SEWER REPORTS,

MAY, 1877.

OFFICE OF THE BOARD OF STREET COMMISSIONERS,  
CITY OF HARTFORD, May 15, 1877.

PROVIDENCE, April 6, 1877.

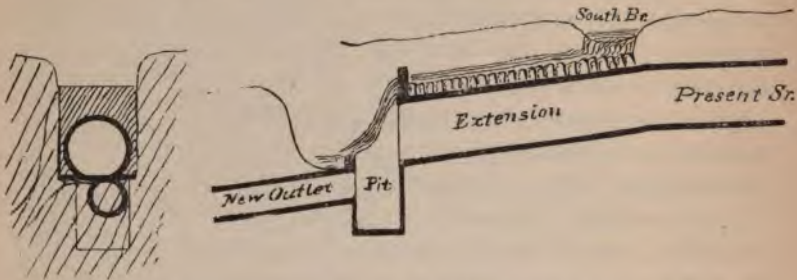
The favorable location of the meadows, across which the brook from the Franklin avenue sewer runs for a distance of about thirty-eight hundred feet on its way to the river, for works of irrigation, suggests the attempt to utilize the sewage in this case. But in addition to the consideration above mentioned, we have the fact that for the present the district is thinly settled, the population being estimated at about 2,000 persons, or a little more than two persons per acre, and the length of travelled streets is also very small when compared with a thickly populated territory. On this account the amount of manurial property, which can be obtained from the sewer, will be very small in comparison with the cost of the works that will be necessary to make it available. From several analyses the value of the Boston sewage has been estimated at one cent per ton, and that of Worcester at seven-eighths of a cent per ton, from which it will be seen that a large body of water must be handled for a small return. A disagreeable odor sometimes arises from sewage irrigated lands, and this, I suppose, would be objectionable from the locality of these meadows. While I think the conditions are not now favorable to a disposal of this sewage by irrigation upon the meadows, I would yet so dispose of it that irrigation may be resorted to at some future time, if it is found to be desirable. This can be done by constructing a sewer of sufficient size to take the liquid refuse from buildings, and the first run of water from the streets in a storm, from the outlet of the main sewer to the river, allowing the excess in heavy storms to overflow into the present brook channel.

What the size of this outlet sewer should be, is a debatable question; though there is no doubt but that it should be larger than is needed simply for taking the liquid refuse from buildings, for the reason that the first wash from the streets in a rain storm, carrying the droppings from animals and other foul matter, is often more offensive than the discharge from water-closeted houses. Any overflow whatever from the main sewer into the brook channel during a storm, will carry, in some degree, a mixture of the foul sewage with the storm waters, and

a line of division between the quantity that can be carried through the outlet sewer, and that which must overflow into the brook, should be drawn so that the amount carried into the brook shall not be practicably objectionable. Upon consideration, I think a sewer four feet in diameter should be provided, from the outlet of the main sewer, to the river, which will have a capacity to carry, when the Connecticut river is not higher than five feet above the city base, a little more than one-sixth the volume that the main sewer must be expected to discharge in such storms as are liable to occur at intervals. This will leave about eighty-two per cent. of the storm waters, at such times, to flow through the present brook channel. Storms that will yield a greater discharge than thus provided for are of rare occurrence, and need not be particularly considered in our construction of an outlet. But few storms in each year would cause an overflow into the brook. In determining upon a size for the outlet sewer, I take into account the future occupation of the territory by buildings and streets. It is possible, and even probable, that I have set the standard of purity for the water that is to overflow into the brook, too high, and if, on thorough examination of all the circumstances, it should be decided that this is the case, the size of the new outlet sewer, and the consequent cost, can be correspondingly reduced.

As the meadows are flooded, sometimes very deeply, by Spring freshets, and large bodies of ice are likely to sweep along the surface, it is desirable to place the sewer below the surface at all points. For this purpose I would locate the inside crown of the sewer at grade five, and run it level from the river to a creek thirty-two hundred feet distant therefrom; thence let the crown rise on a uniform grade towards the invert of the end of the present main sewer. This will, under ordinary circumstances, place the sewer under an internal pressure, which may at one point be equivalent to about twelve feet head of water, which must be provided for in the plan of construction adopted for the sewer. Although this outlet sewer will, when running full, have a velocity about double that which is required to keep it cleansed from deposits of sewage matter, there will be a tendency to gather deposit during a dry weather flow, and it is possible that some means besides the scour of the storms will be required to keep it clean.

The present main sewer should be extended about seven hundred feet on a falling grade of 0.81 per 100, the present canal through the rock-cutting being deepened for that purpose. A pavement should be laid over the crown of this extension, and a bulkhead wall built over the new outlet so that the lateral brook, which enters the canal at the present outlet, may be conveyed over the extended sewer, and deflected around the new outlet into the brook channel. Below the new outlet a chamber and pit should be built, into which the ordinary flow of the main sewer will fall, and in which any heavy matter will settle and remain until taken out. From the upper part of this chamber, the new sewer should take the flow it is designed to carry.
